SUBDIVISION REVIEW SHEET

CASE NO.: C8-2020-0112

SUBDIVISION NAME: Braker Valley Subdivision Preliminary Plan

**CITY OF AUSTIN –DEVELOPMENT SERVICES DEPARTMENT
SUBDIVISION APPLICATION – MASTER COMMENT REPORT**

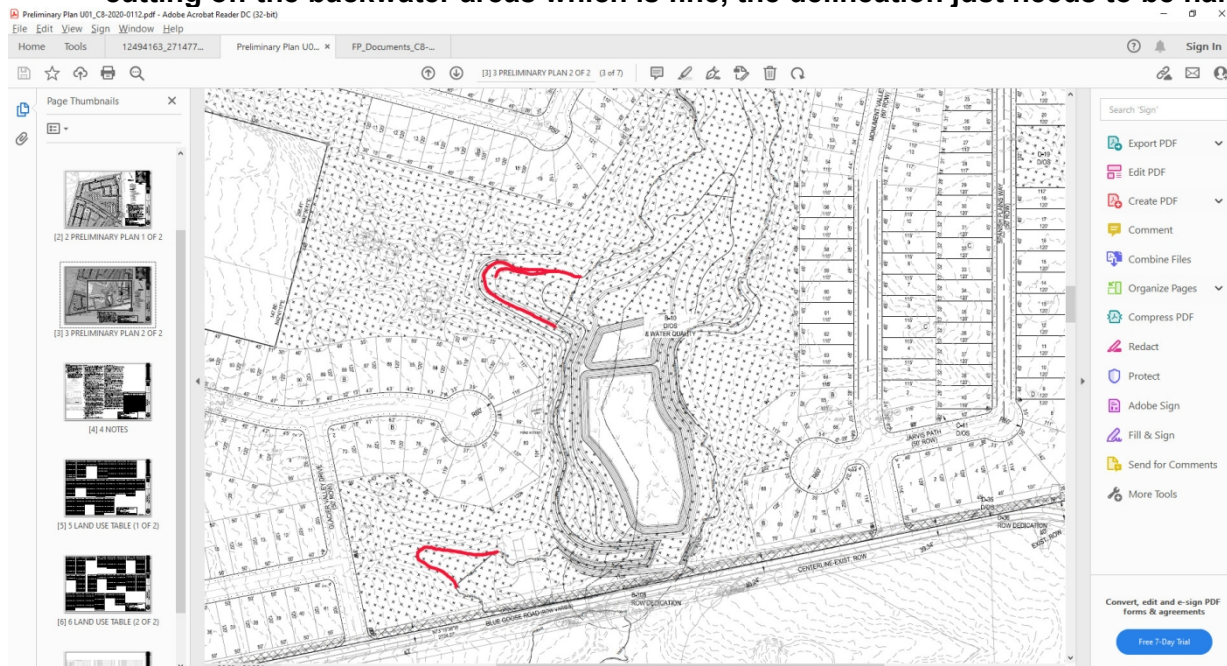
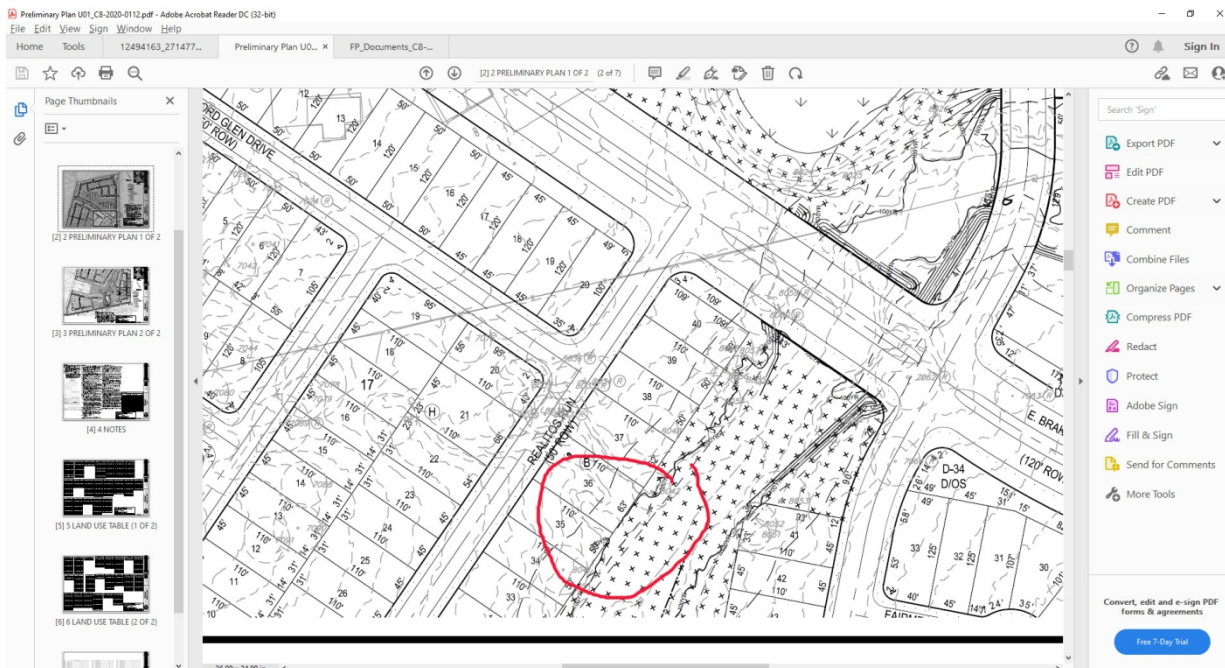
FP8. The site, as shown on the plan provided, is not in compliance with LDC 25-7-33.

- a. Please delineate and clearly label the Proposed Site Conditions Fully Developed 100-year floodplain (a line type is indicated [line dash dash line], but that particular line type is not on the plan set)

UPDATE 1: Floodplain is delineated, but it cuts off in backwater areas – please extend the floodplain up these backwater areas (I'm pretty sure the model bounding polygon is cutting off the backwater areas which is fine, the delineation just needs to be hand added).

(in the one directly above, it is possible the floodplain IS supposed to do this, but there is no grading shown which would make me think that it would follow along the property line, hence I'm lumping it under the "bounding polygon" issue)
